ADDENDUM NO. 3

PROJECT NO. SW-23-01-01
STORMWATER MAINTENANCE AND OPERATIONS
BUILDING

**ADDENDUM NO. 3
TO
PROJECT NO. SW-23-01-01
STORMWATER MAINTENANCE AND OPERATIONS BUILDING**

ADDENDUM NO. 03
Stormwater Maintenance and Operations Building
SW23-01-01
August 14 2025

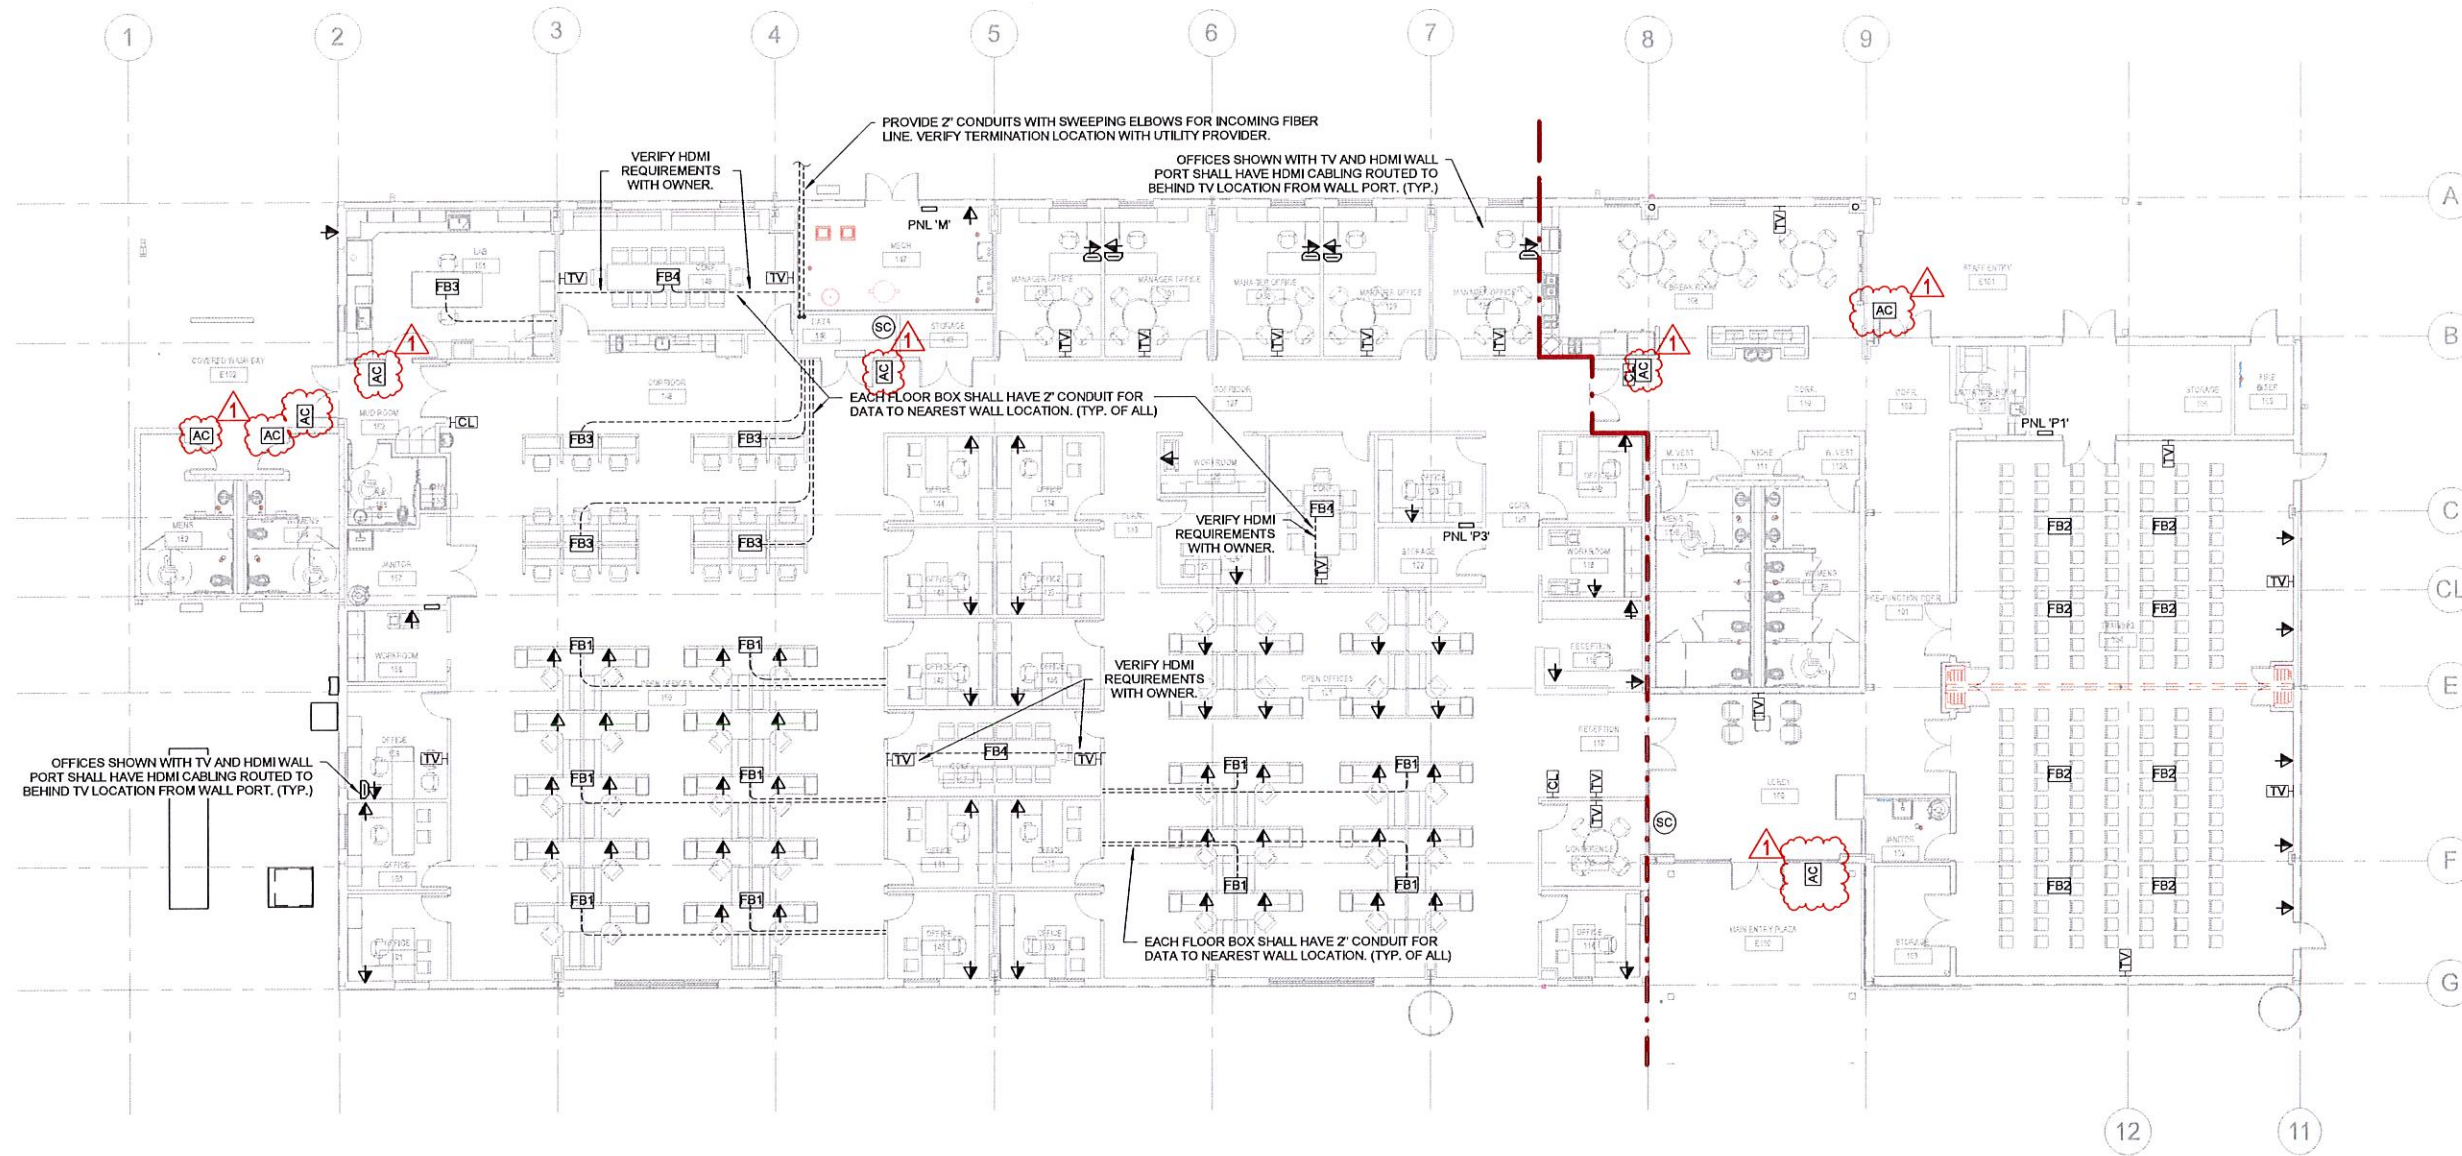
1. Sheet G0-03
Revise pay item 10 to read "NOT USED".
Revise the quantity on pay item 89 from "4,252" SF to "3,828" SF.
Add line below pay item 90 to read " | 90B | 095123 | 9.ACT3.2 – ACOUSTICAL CEILING TILE AND GRID (HIGH HUMIDITY) | 1,7 | SF | 427".
2. Sheet G0-04

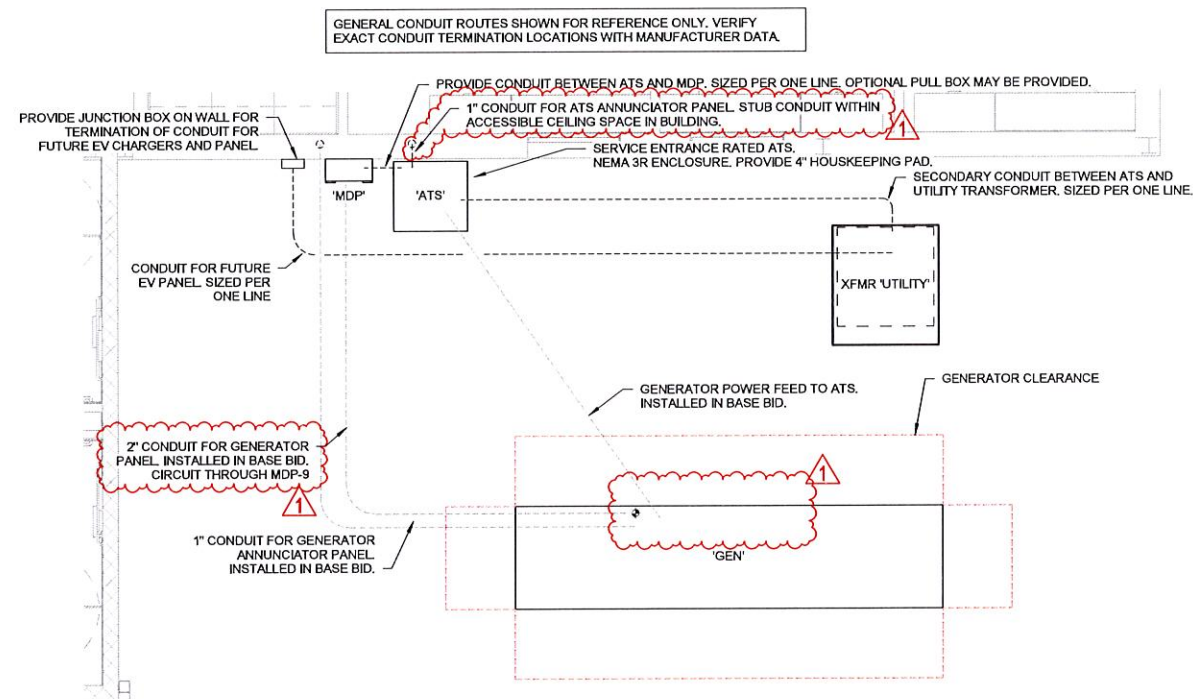
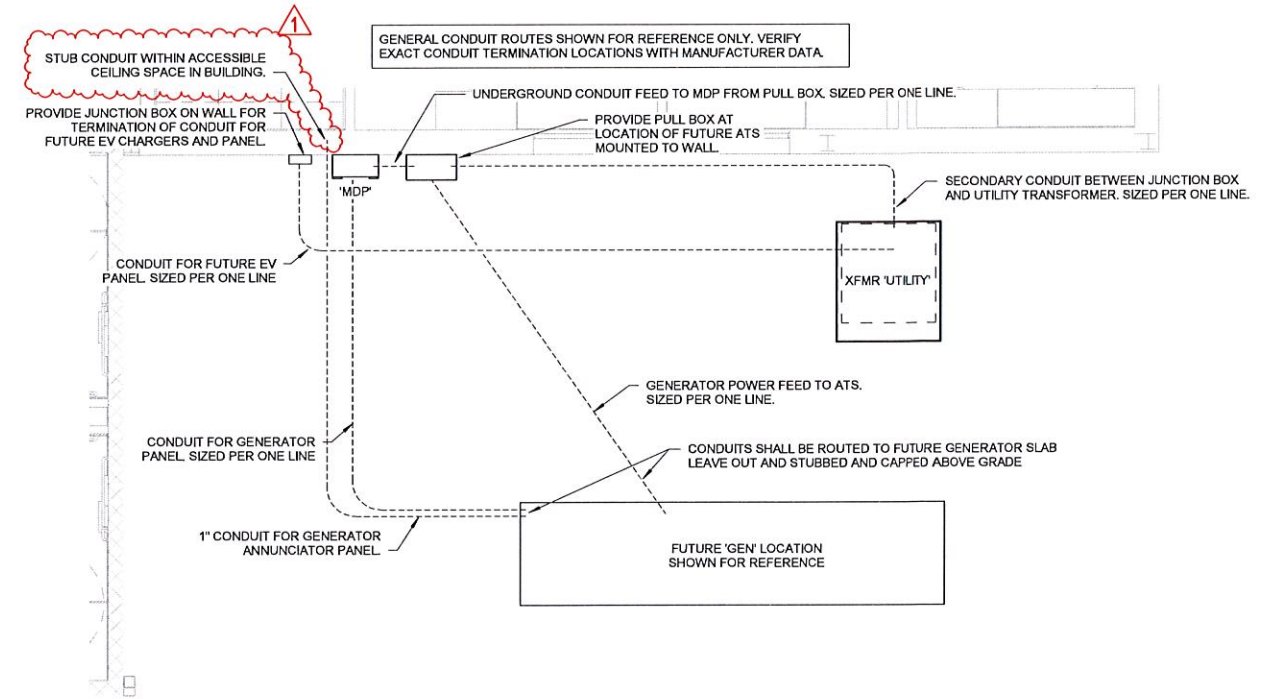
11. Sheet E2-11, Electrical Systems Plan

Add access control per Door Schedule.

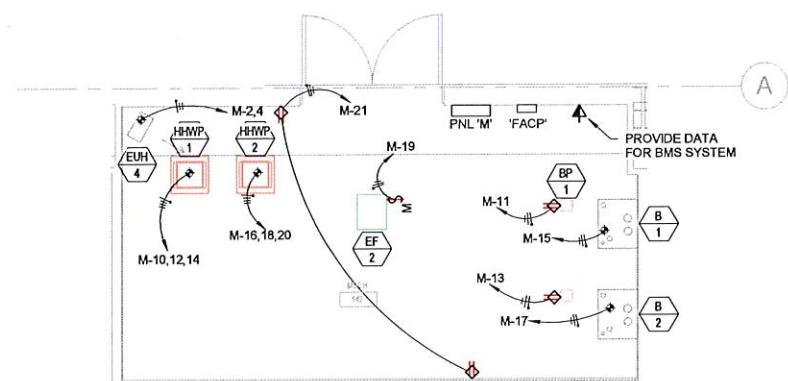
12. Sheet E4-01, Enlarged Electrical Plans

Provided clarification of annunciator panel conduit routing per attached drawings.

Provided clarification to generator panel circuiting per attached drawings.

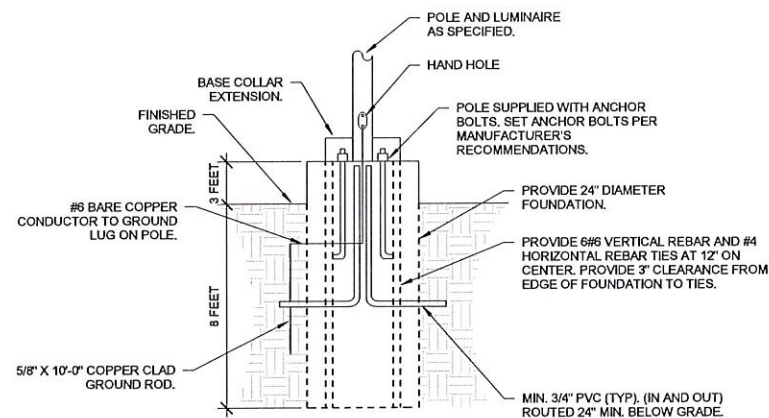
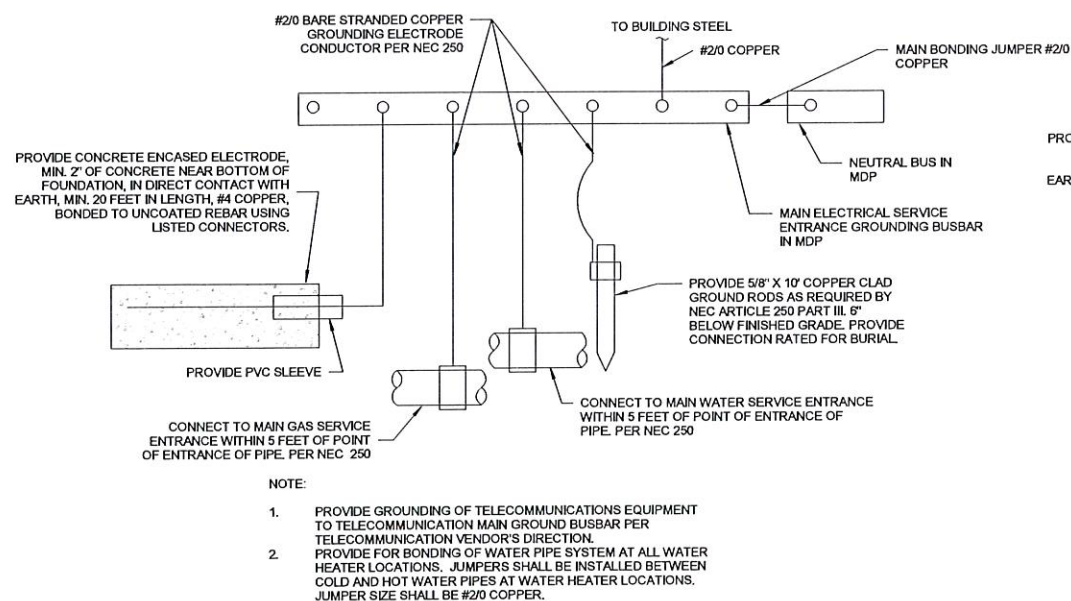
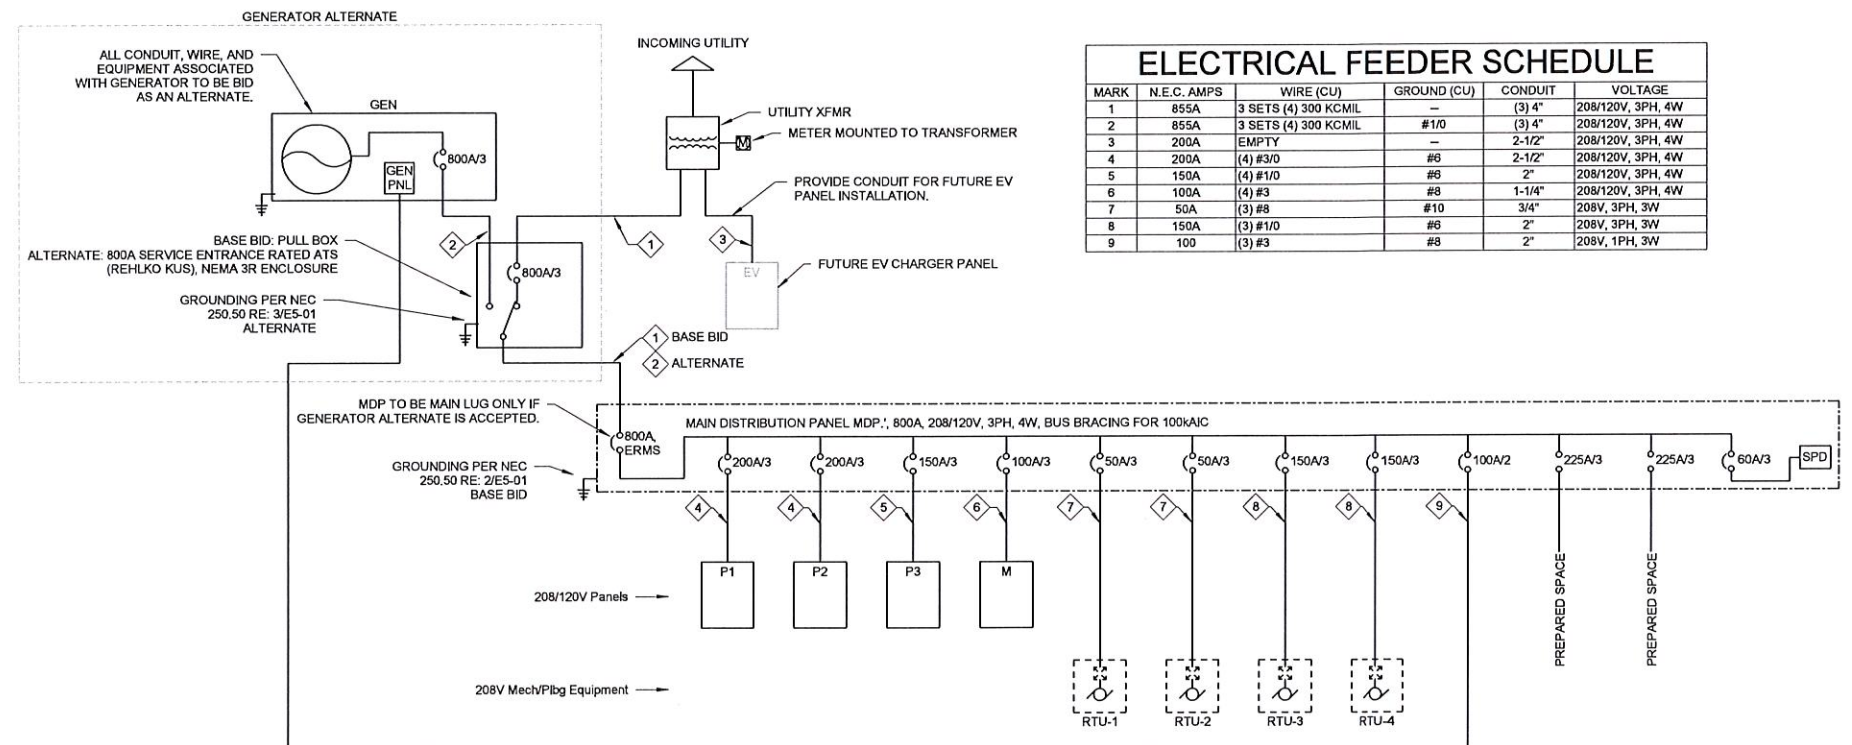
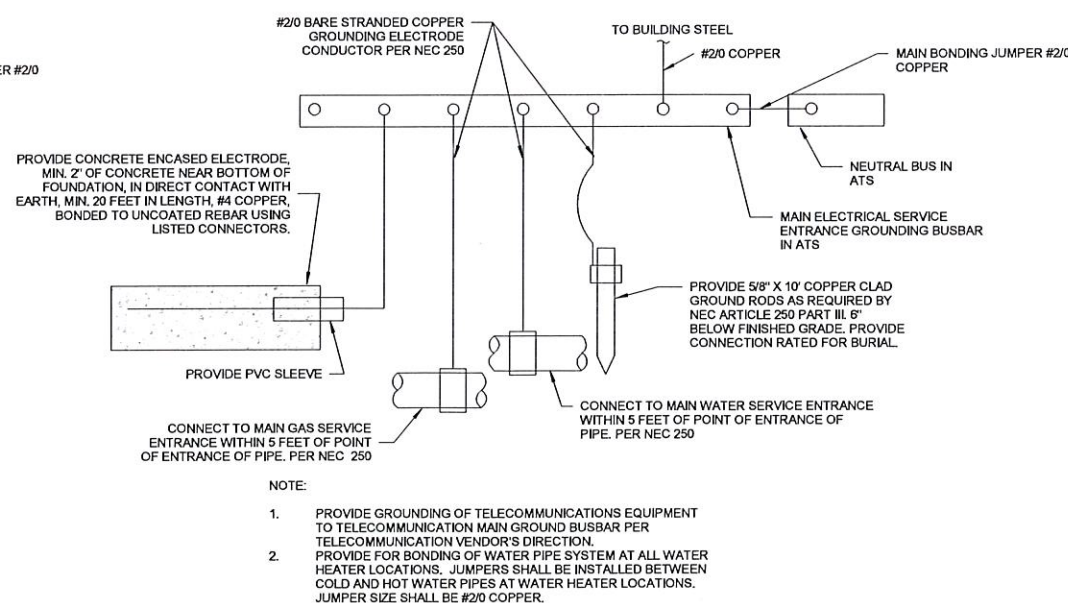
13. Sheet E5-01, Electrical Details

Added 4" housekeeping pad for MDP.

NOTES:
 PROVIDE 4" HOUSEKEEPING PAD UNDER 'MDP'
 MCB NOT INSTALLED IF GENERATOR ALTERNATE IS ACCEPTED
